Re: Basin Electric Power Cooperative  
Case No. PU-11-696 Antelope Valley Station to Naset 345-kV Transmission Line  
Application Amendment

**Amendment to the Application to the  
North Dakota Public Service  
Commission for a Consolidated  
Certificate of Corridor Compatibility  
and Route Permit**

**Basin Electric Power Cooperative's  
Antelope Valley Station to Naset 345-kV  
Transmission Line  
Williams County, North Dakota**

**Case No. PU-11-696**

# Figure 1.0-2: Proposed Additional 345-kV Transmission Line Overview Map

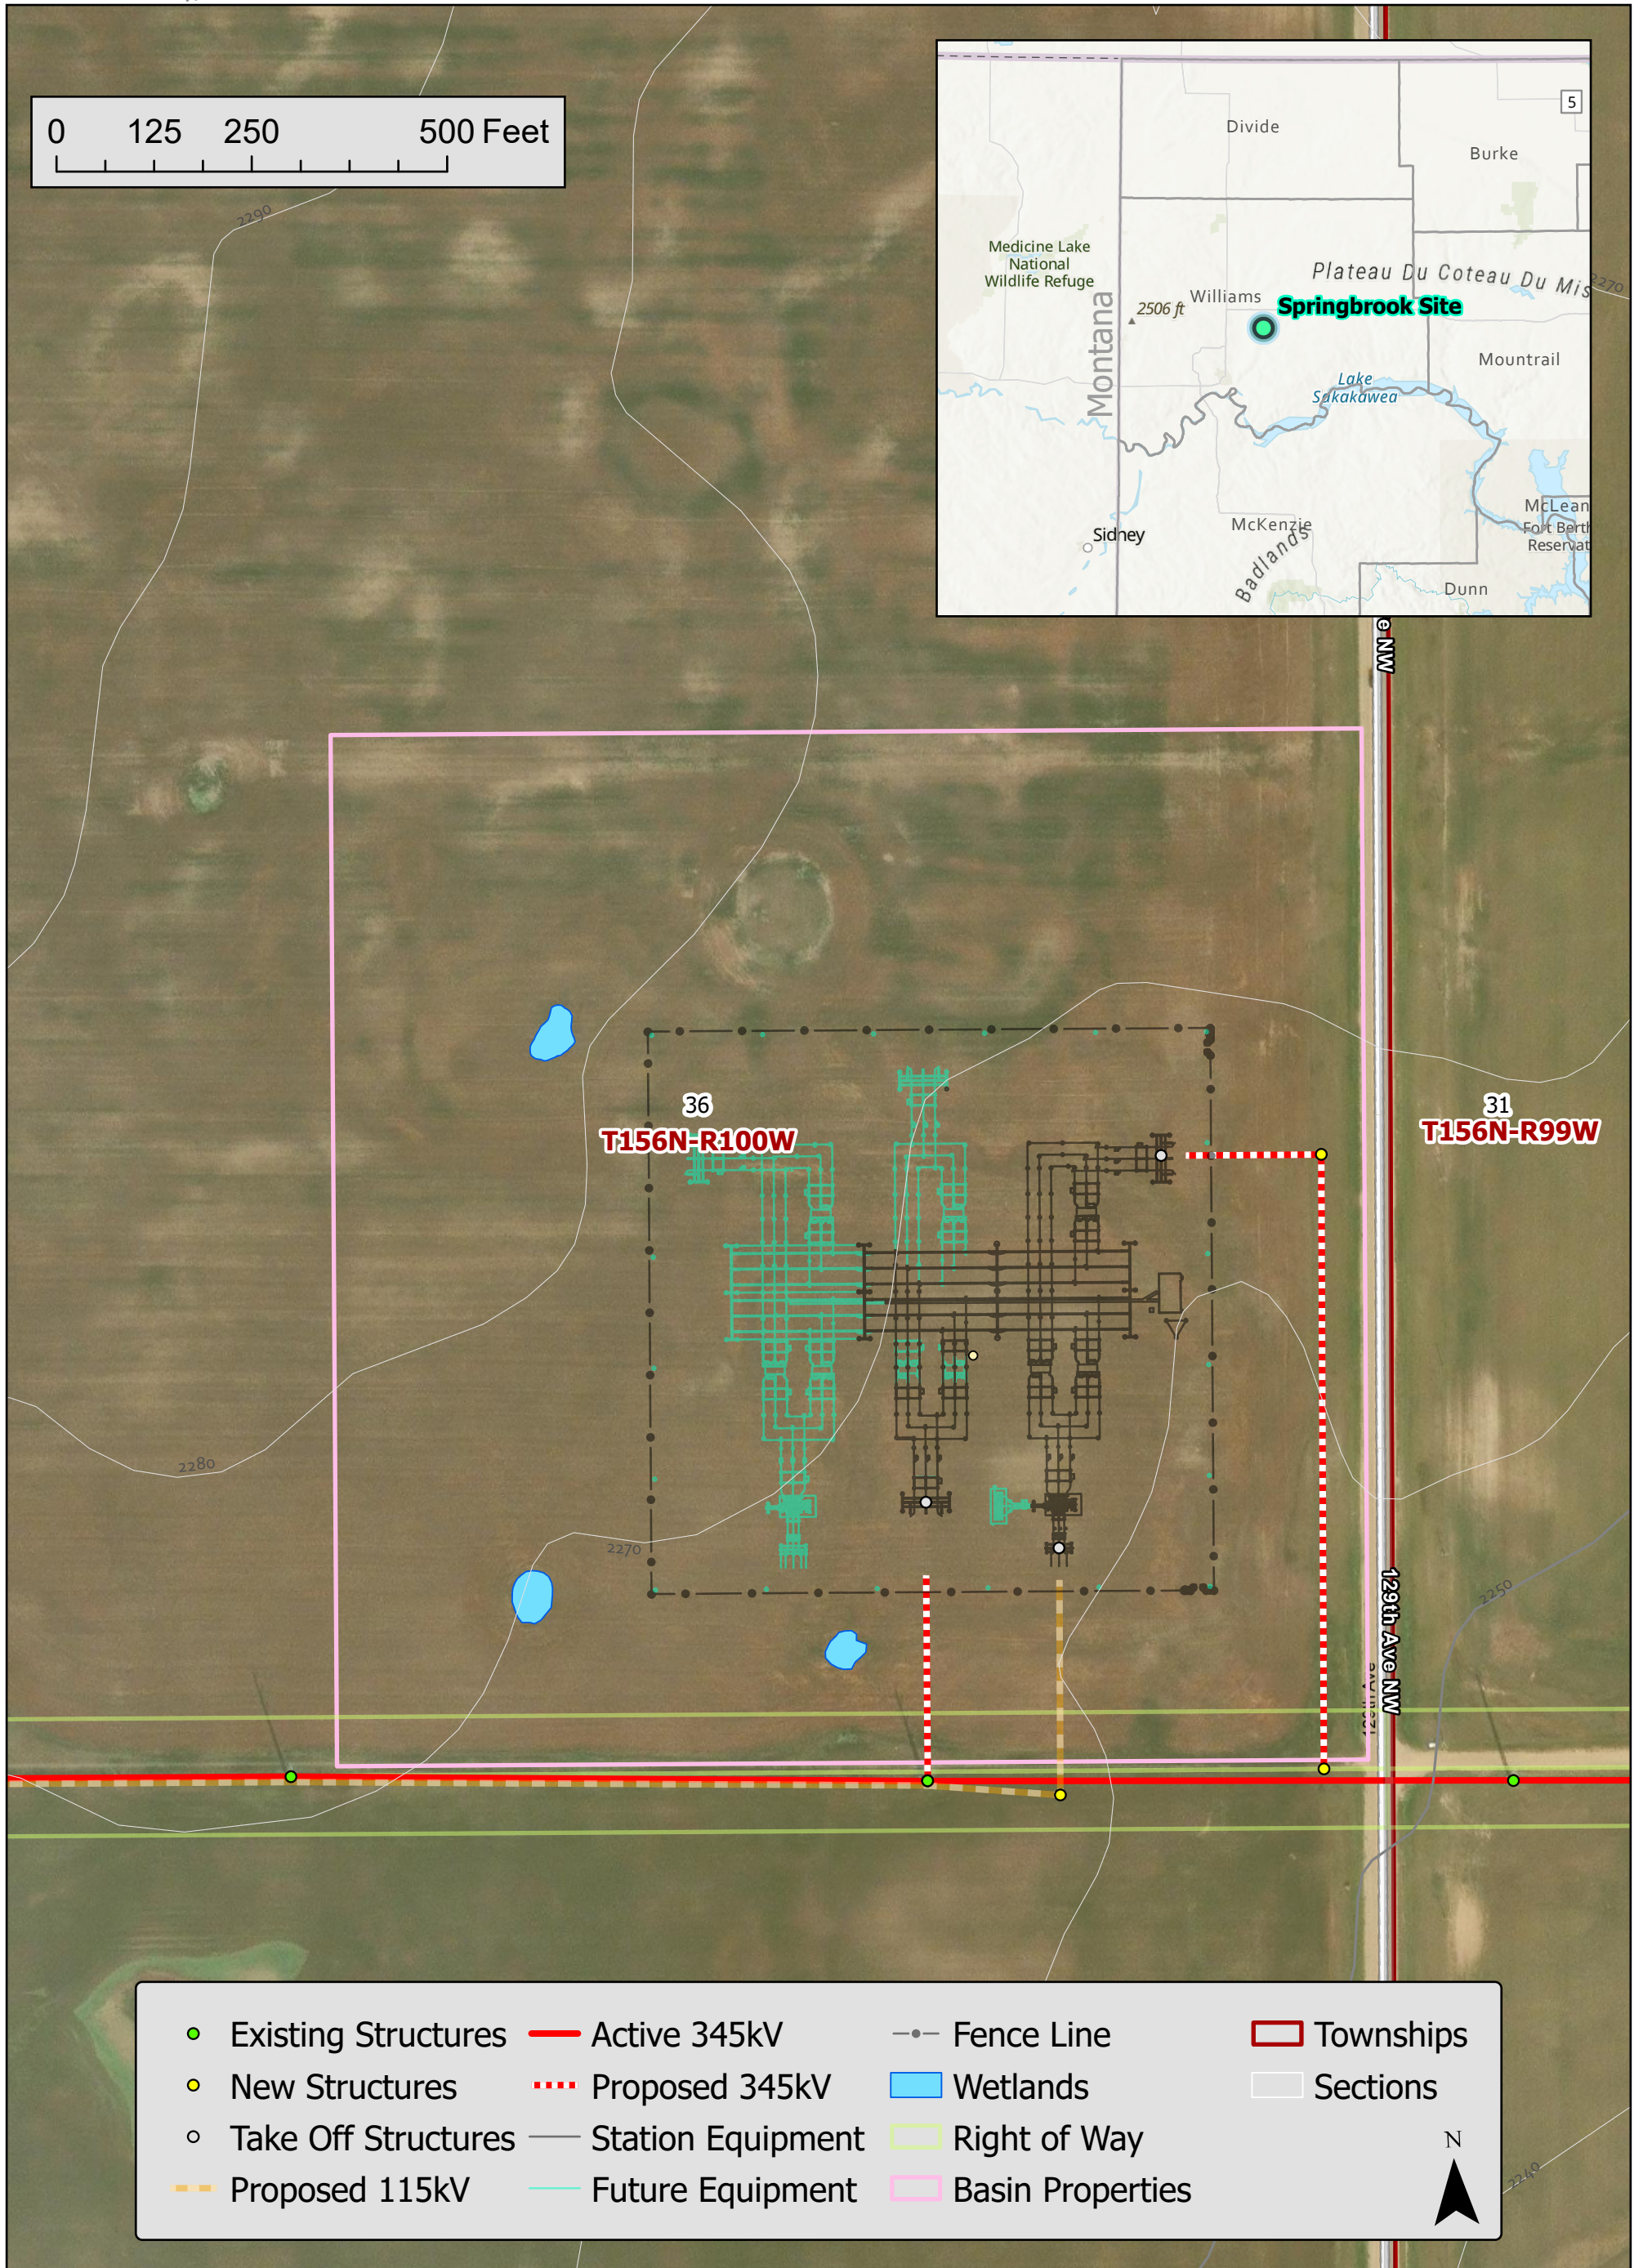
The general Corridor/Route description remains essentially the same as presented in the original application and subsequent amendments. The only change includes the addition of the Springbrook Substation, associated transmission lines, and microwave tower, addressed in this amendment. The proposed Springbrook Substation is located in Williams County, North Dakota, approximately 10 miles northeast of Williston, in Section 36 of Township 156N, Range 100W. The proposed substation will be approximately 155 feet north of the existing AVS to Neseet transmission corridor and will extend approximately 720 feet to the north. One additional 345-kV structure will be approximately 710 feet north of the existing corridor and one additional 345-kV structure will be approximately 33 feet north of the existing transmission centerline, within the existing corridor. Approximately 6.8 miles of 115-kV circuit will be installed on existing AVS to Neseet 345-kV structures, connecting the proposed Springbrook substation to MWEC's East Fork substation (**Figure 1.0-1** through **Figure 1.0-3**).

# Figure 1.0-3: Proposed 115-kV Transmission Line Overview Map

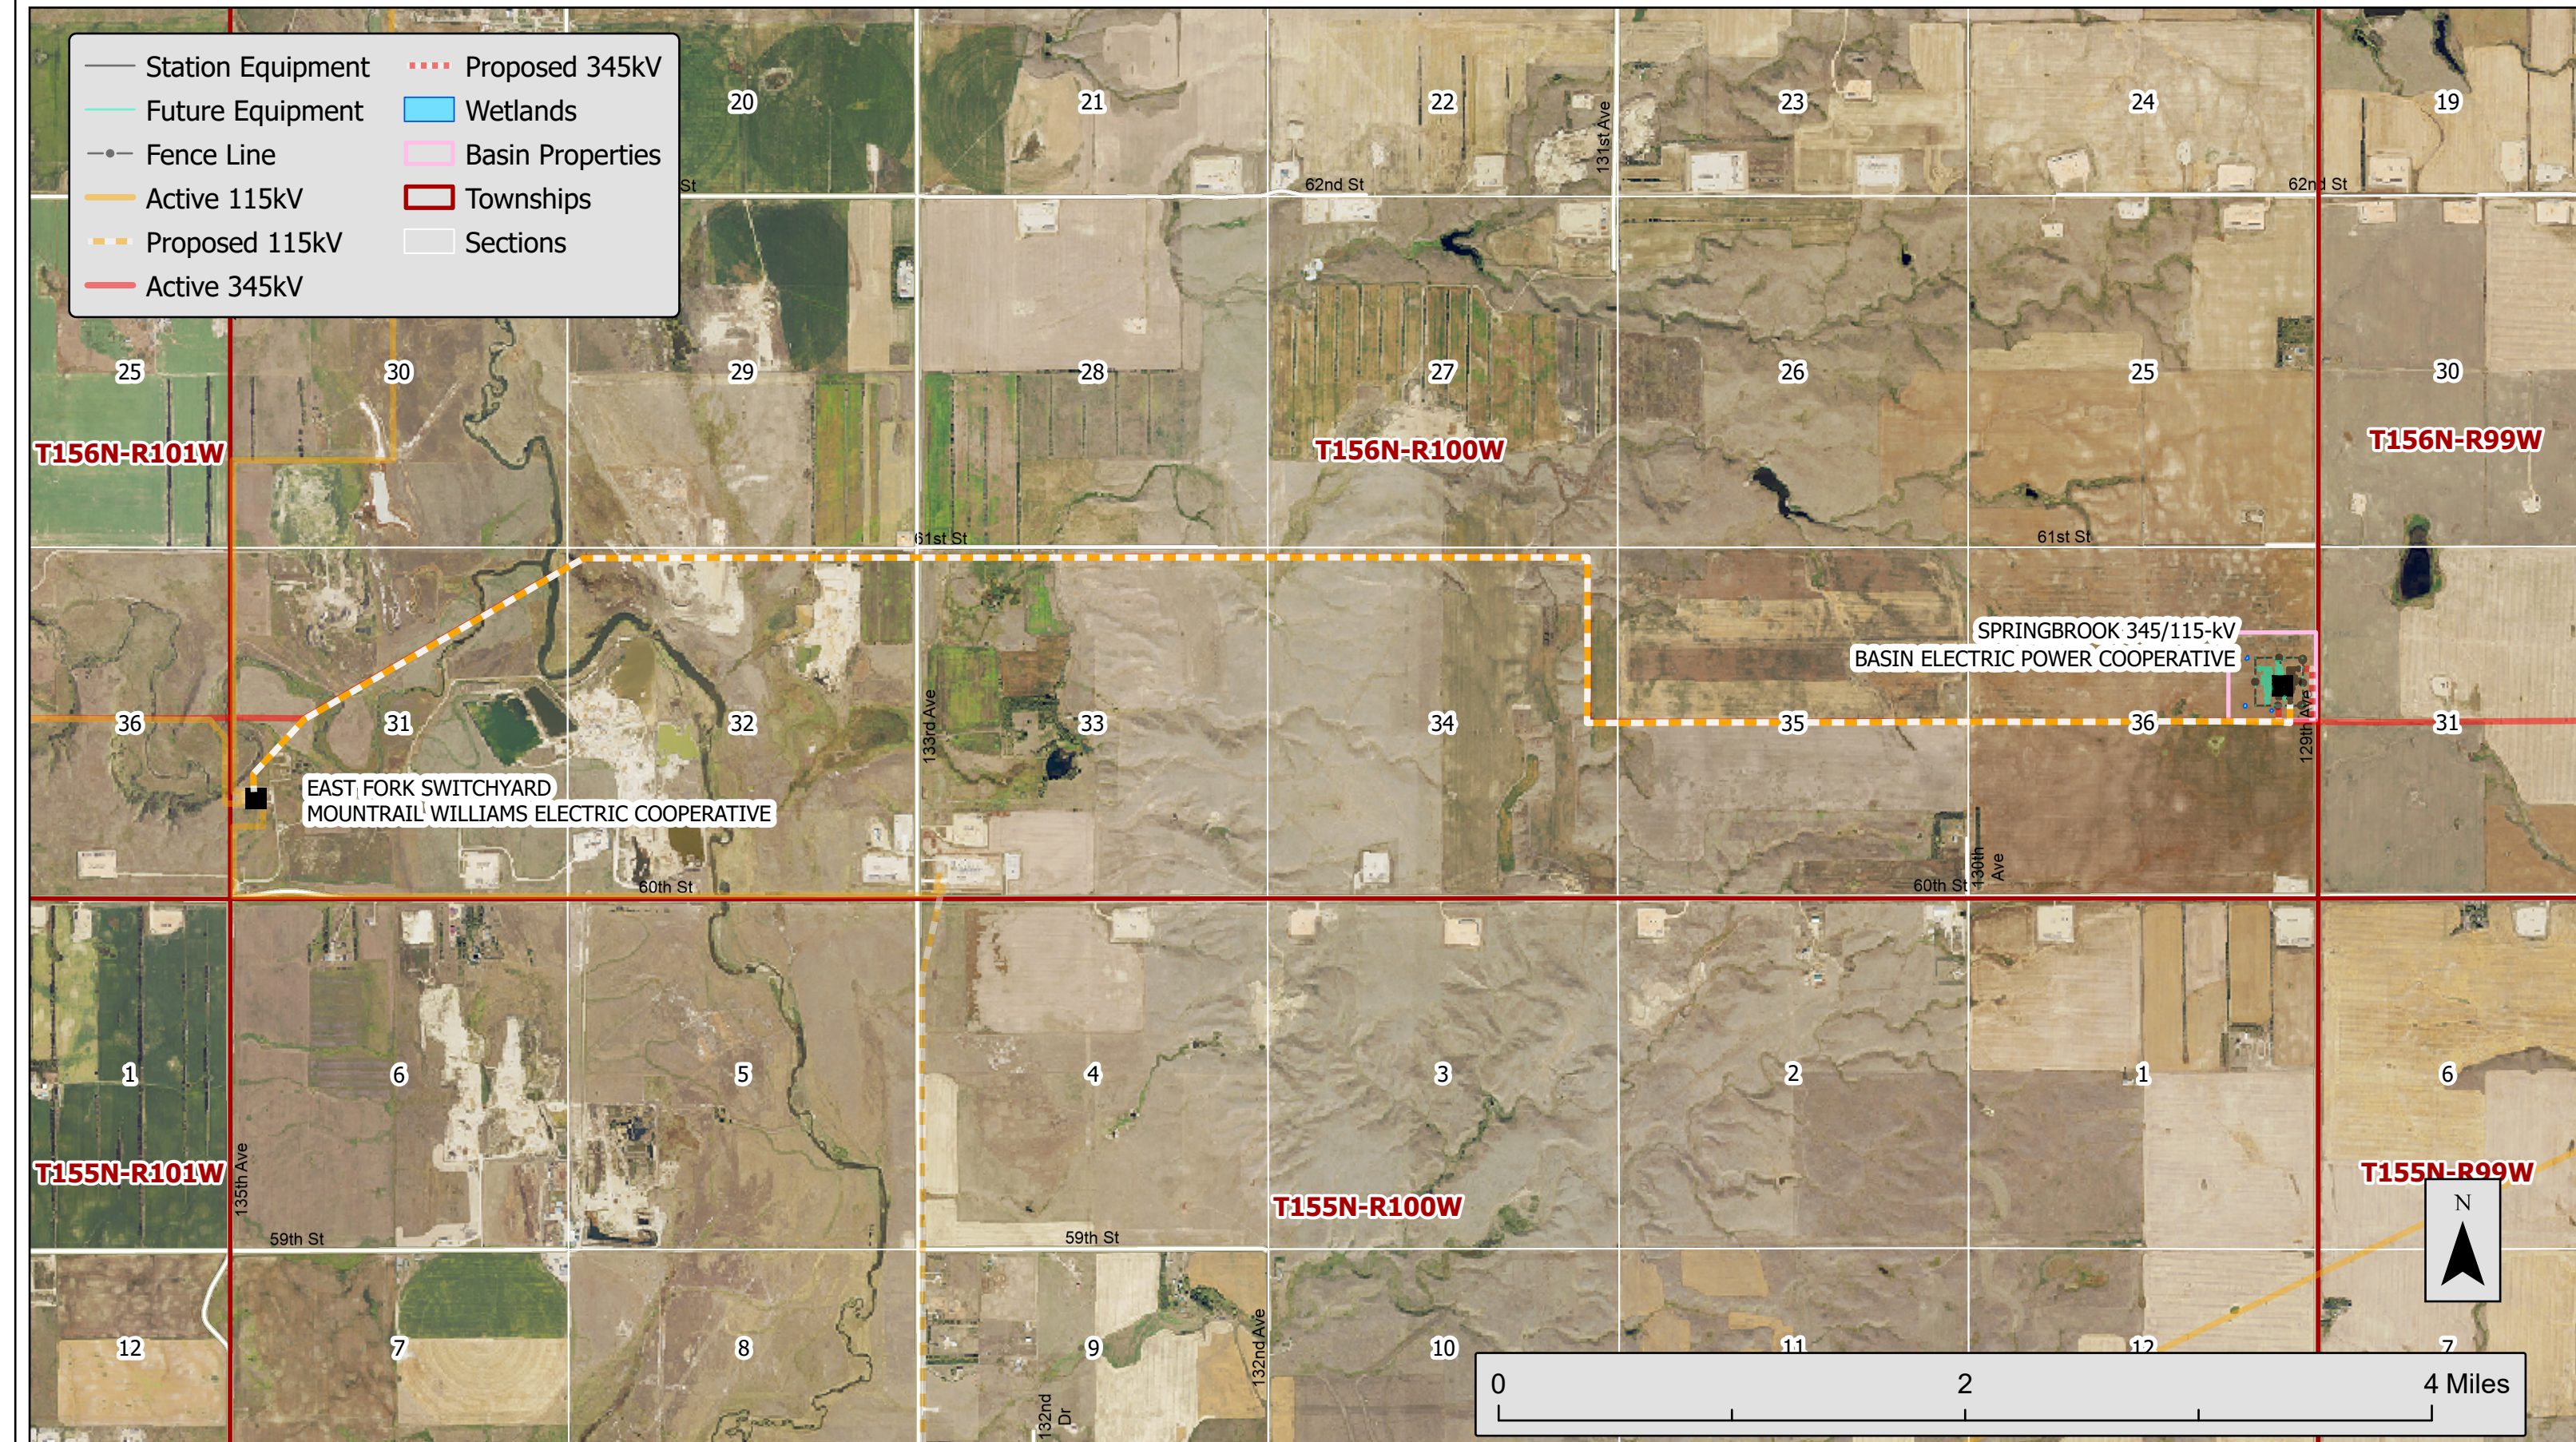
Approximately 6.8 miles of 115-kV transmission circuit will be added to the existing AVS to Neseet 345-kV structures to connect the proposed Springbrook Substation to MWEC's existing East Fork substation. This addition will be accomplished by adding the 115-kV circuit to 37 existing structures. **Figure 4.2-2** shows how the 115-kV transmission circuit will be added to the existing 345-kV structures.
